Central Hudson Gas and Electric Corporation
A&C REBUILD PROJECT - ARTICLE VII APPLICATION
Case 13-T-0469

INTERROGATORY/DOCUMENT REQUEST

Requesting Party and No.: DPS Staff - DPS-001 (MS)

Central Hudson Response No: CHGE-001 (DPS)

Notes: Basemap: ESRI Online Streets.

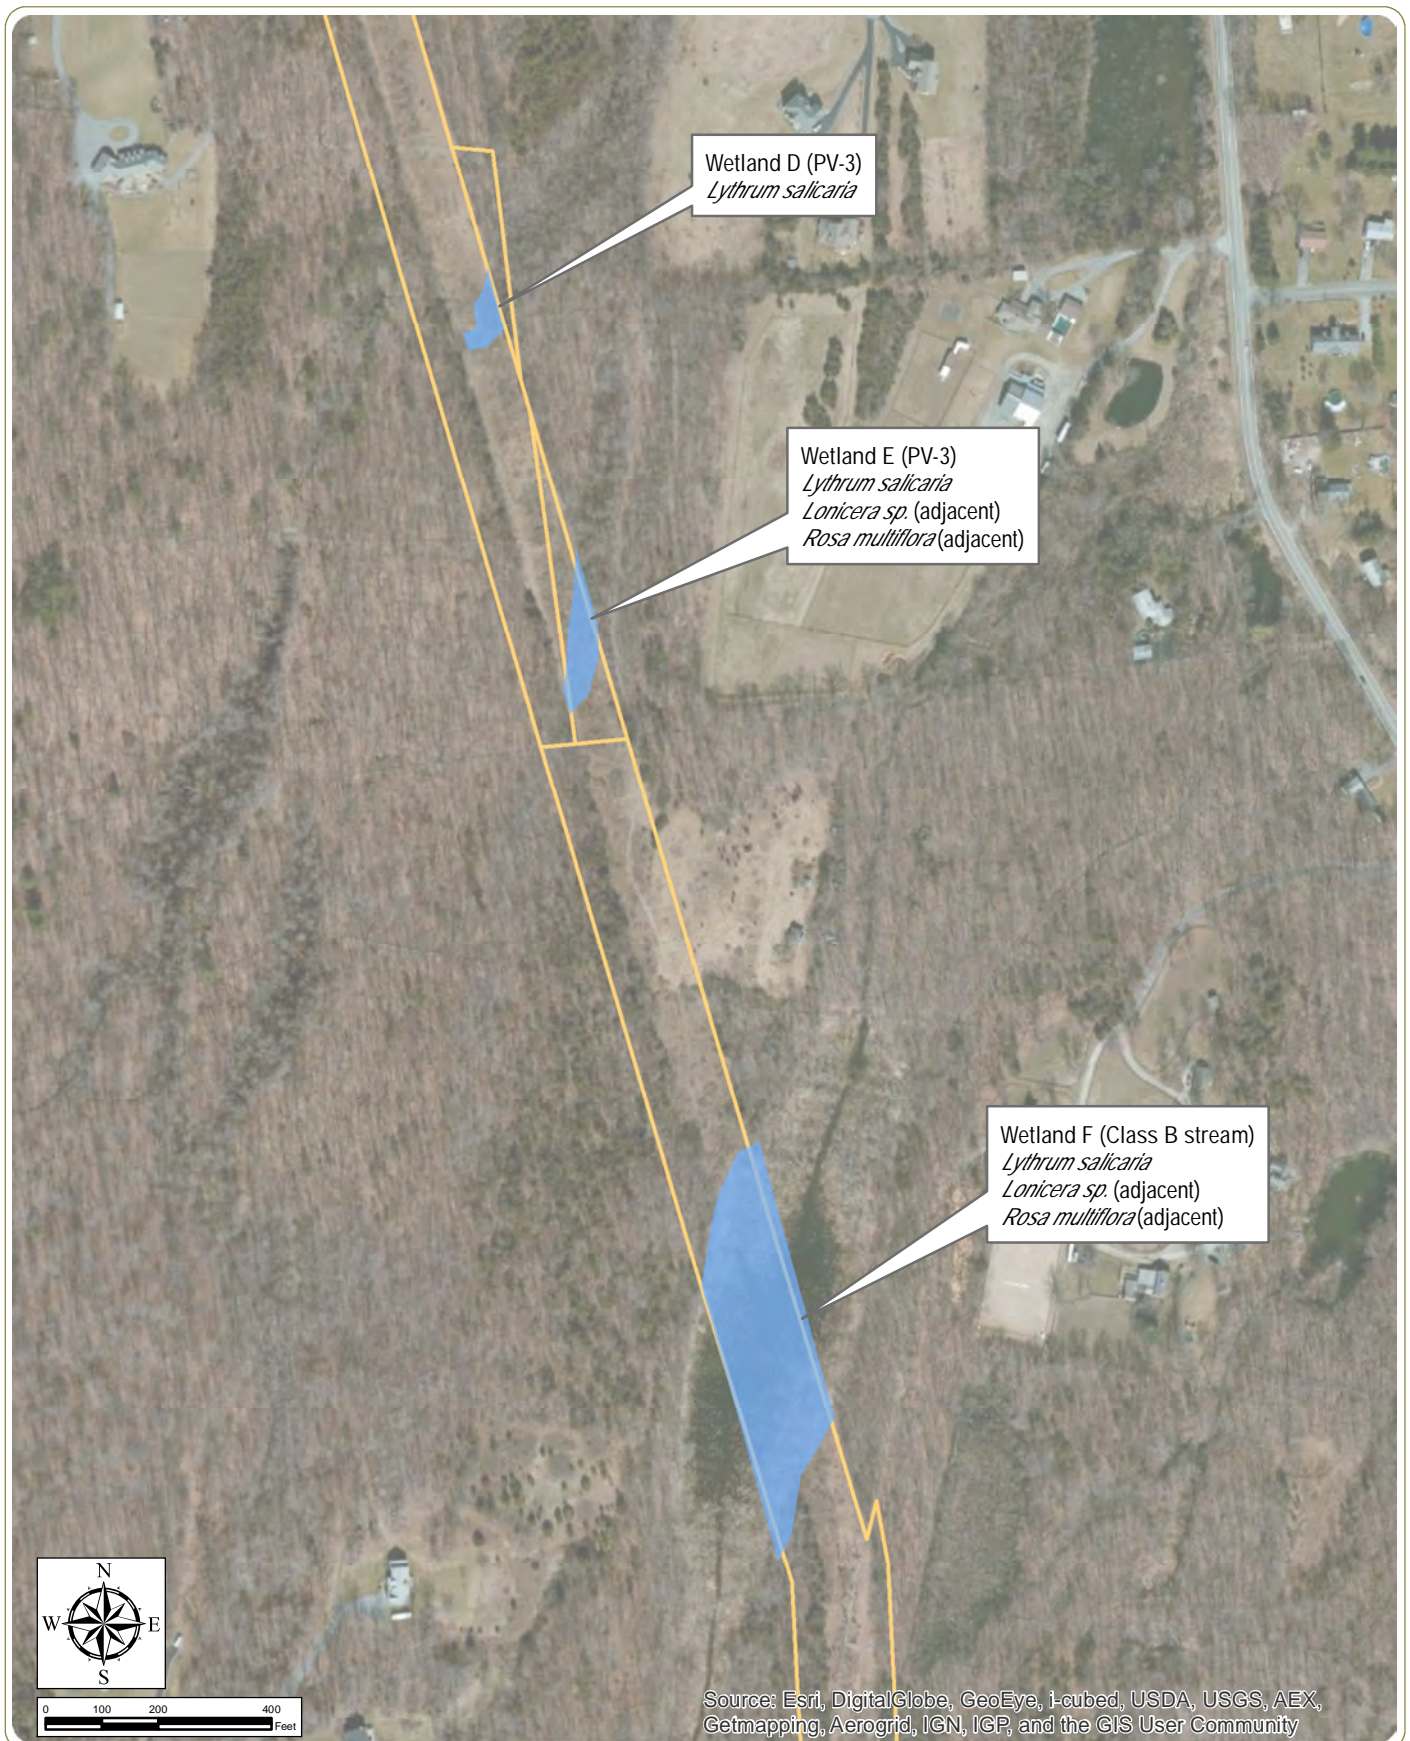
17. Provide a project ROW map locating each State wetland and protected stream, and list any invasive species occurring within each of those areas.
18. For general 115 kV construction does the Company use any of the following types of structures or foundations:

A & C 115KV LINES
EMF R.O.W. CROSS SECTIONS
SHEET 1 OF 8

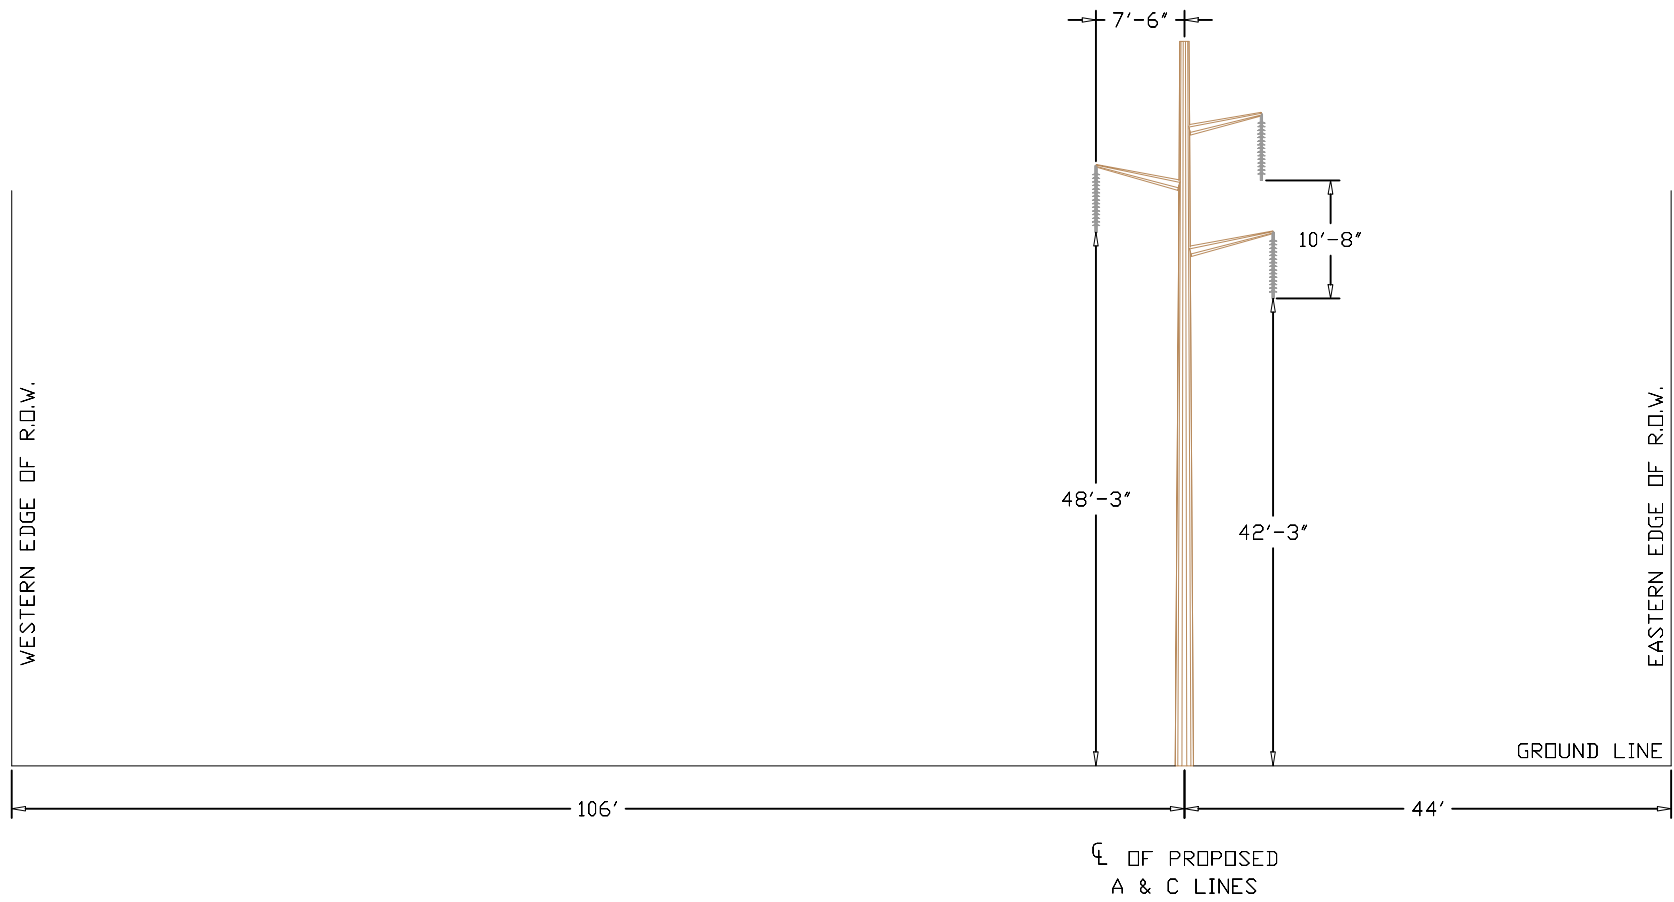
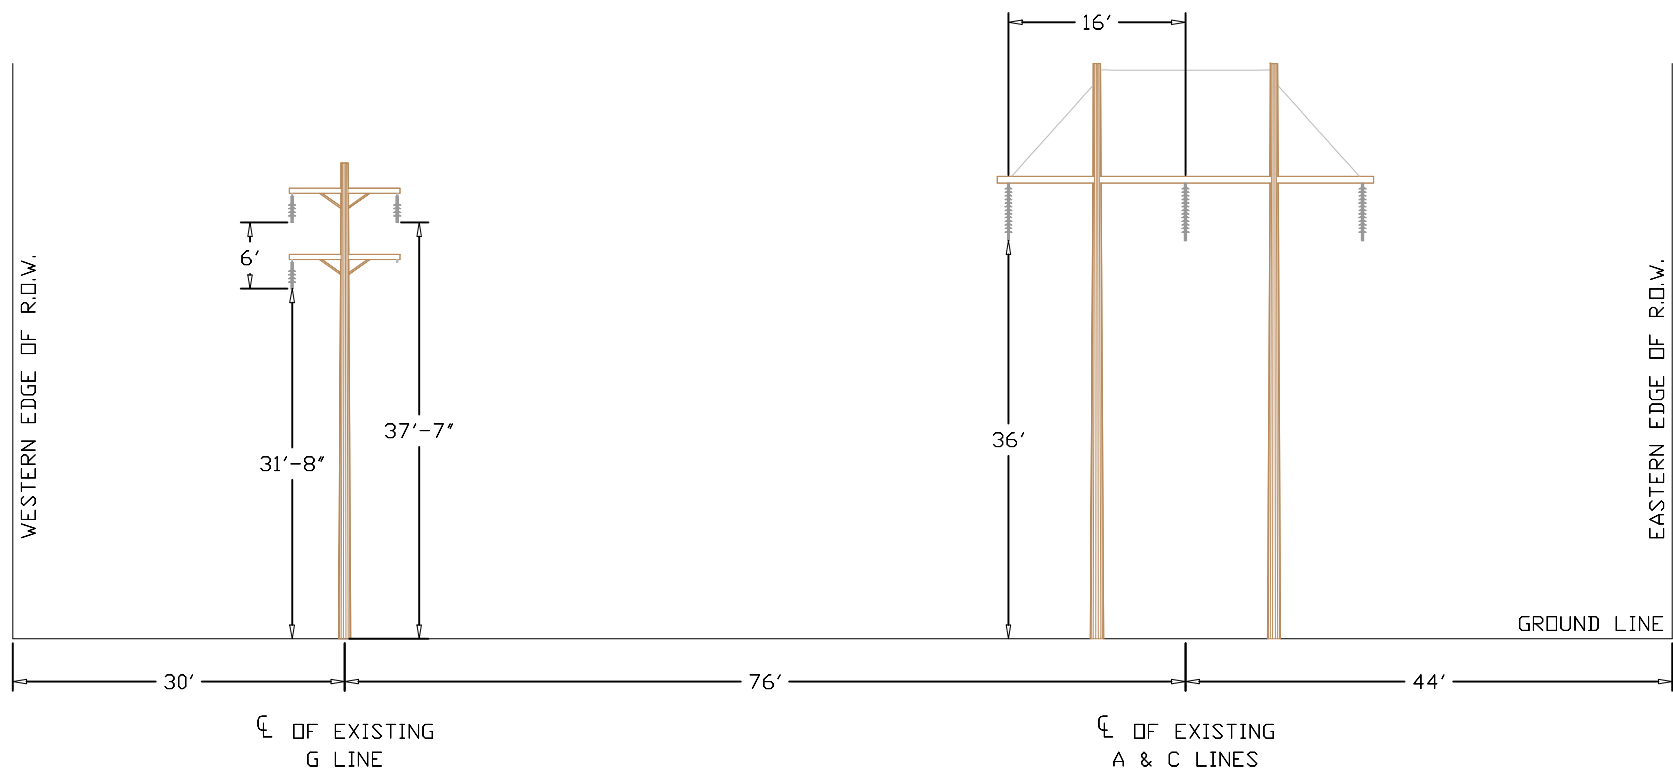
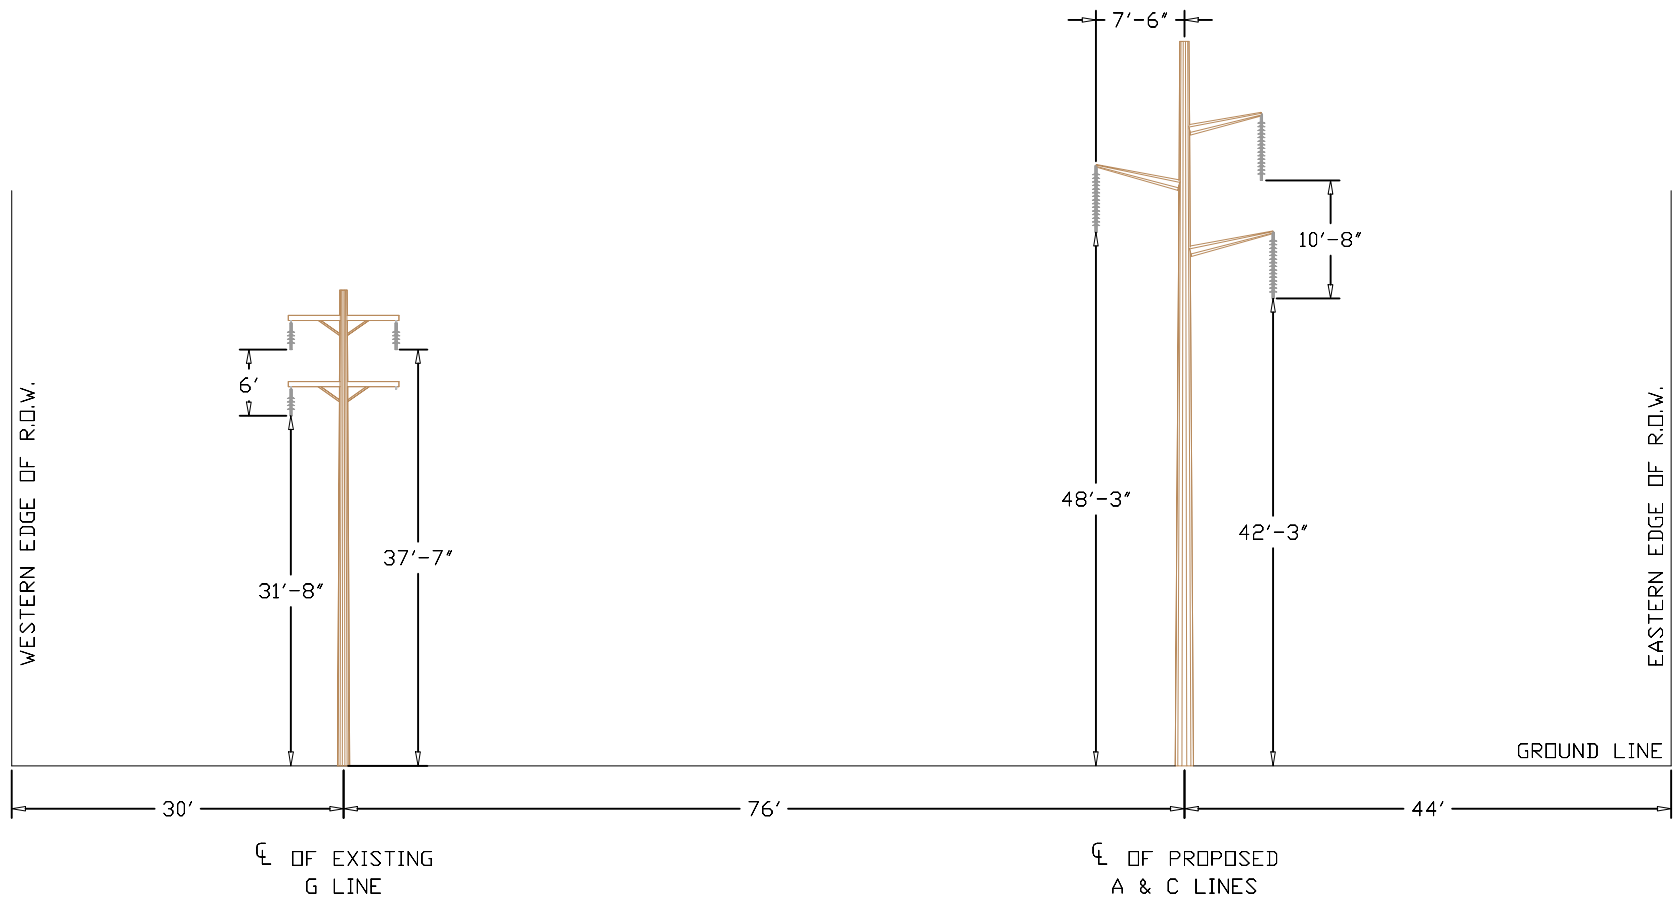
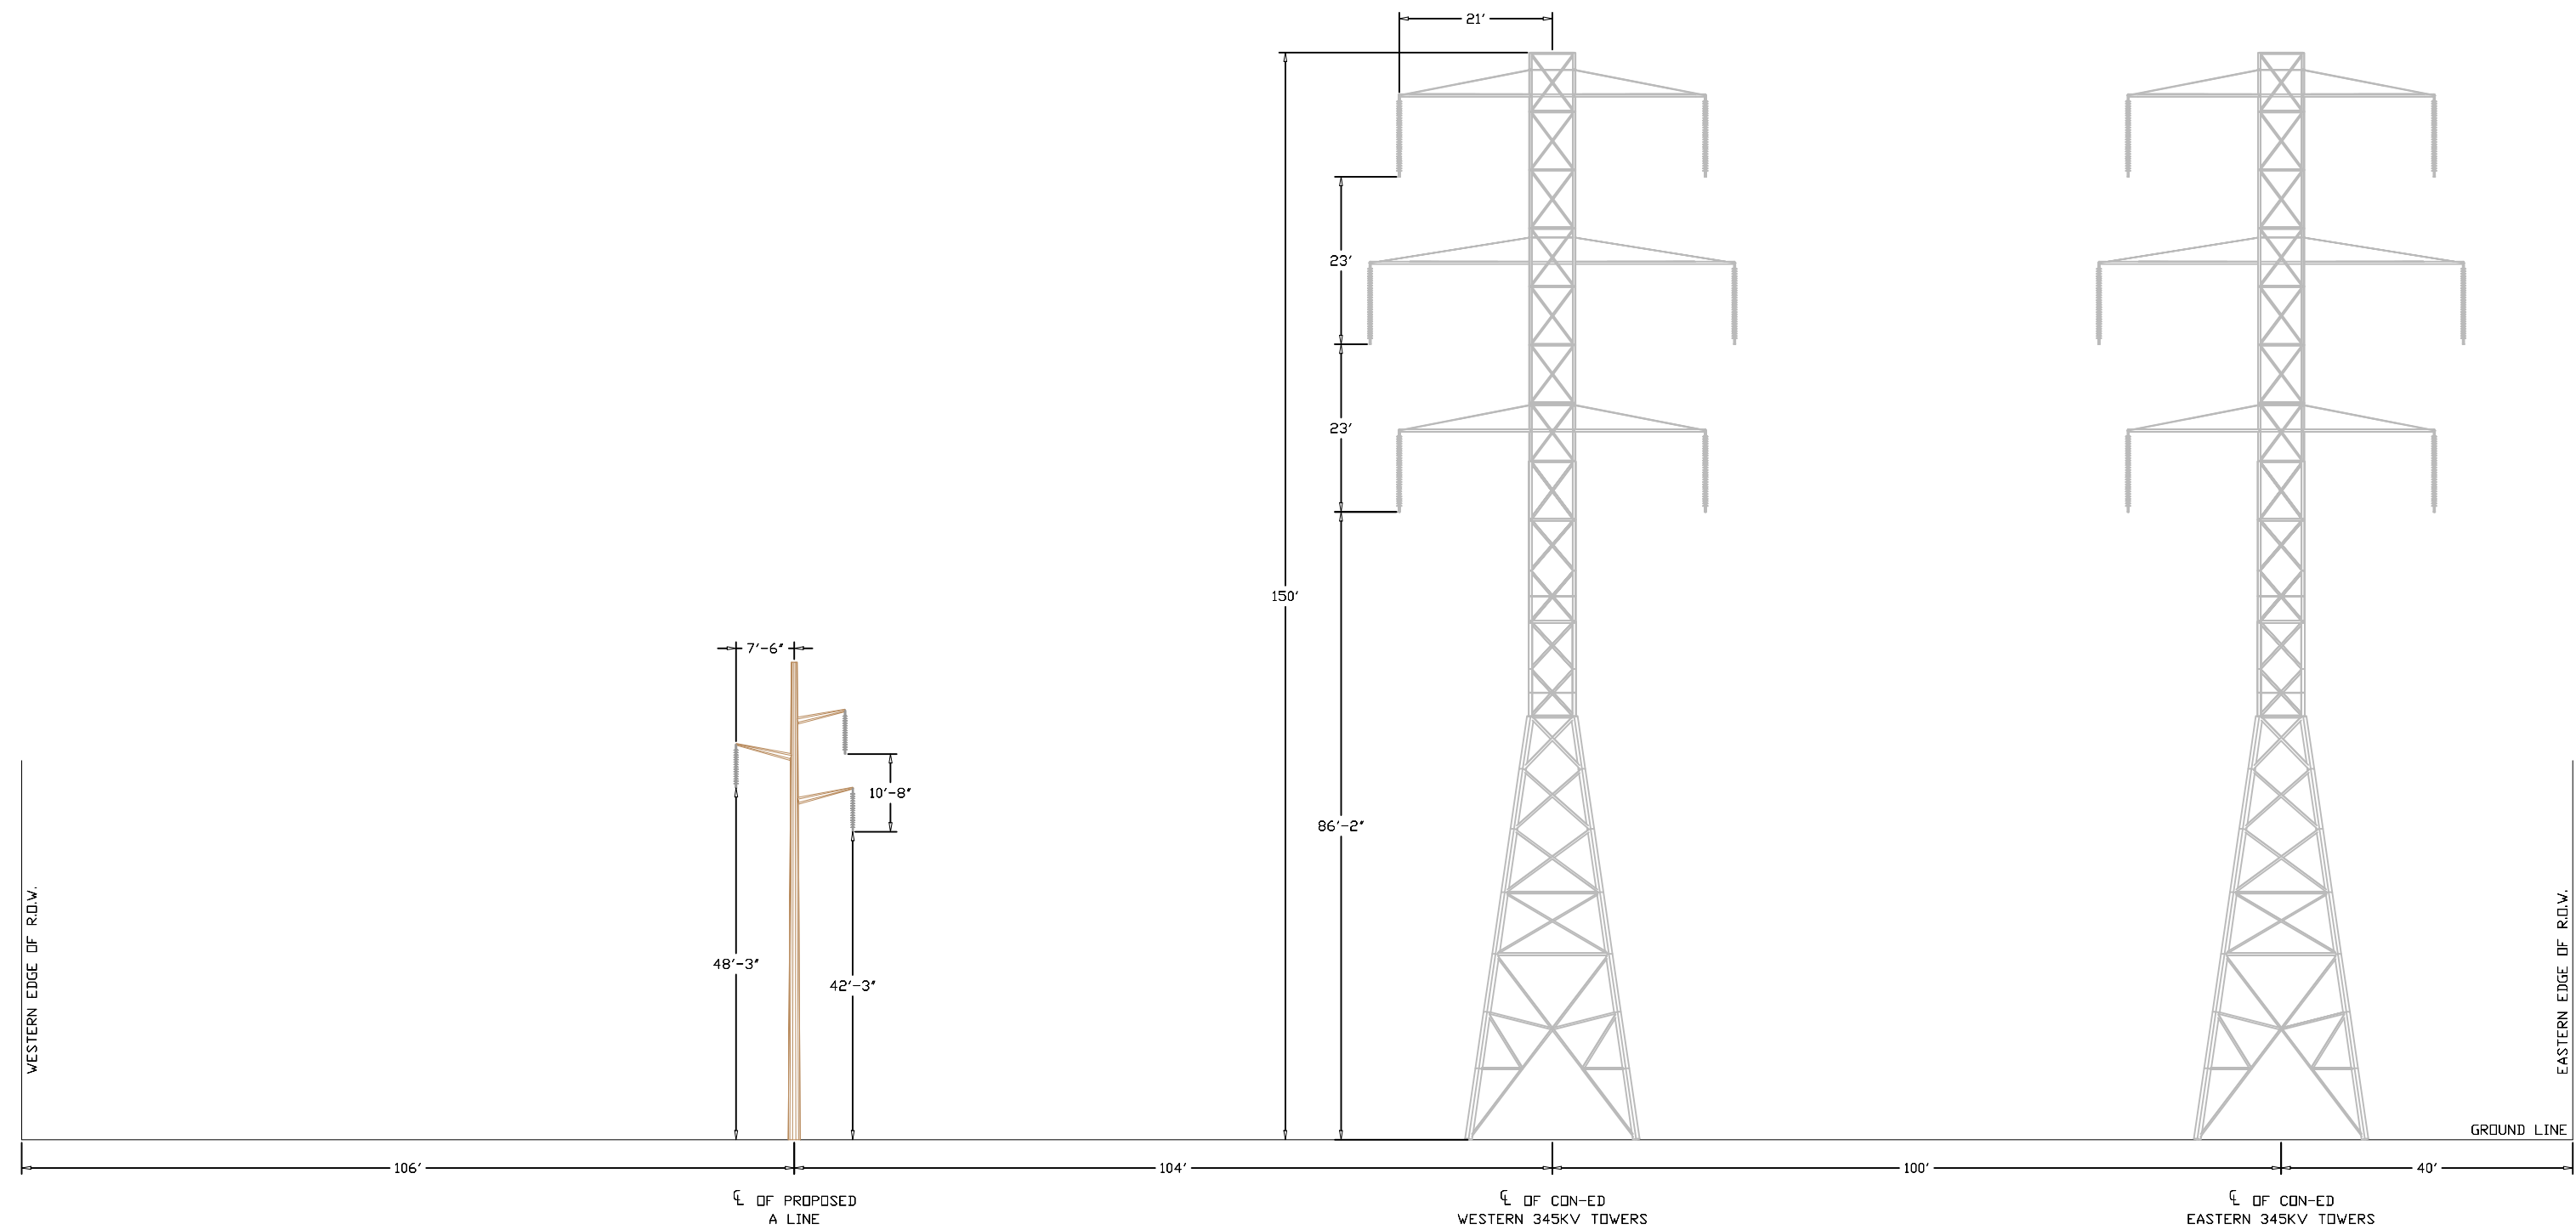
Provide the engineering drawings for the Consolidated Edison-owned lines and the Central Hudson Gas and Electric Corporation-owned A&C lines used to calculate the EMF levels that were provided in the Application for various portions of the right-of-way (ROW). The drawings should be to scale and include the dimensions of the structure and spacing of the conductors and ground wires.

*The drawings used to calculate the EMF levels are the cross-sections (8 sheets) attached as **Exhibit A** to this Response.*
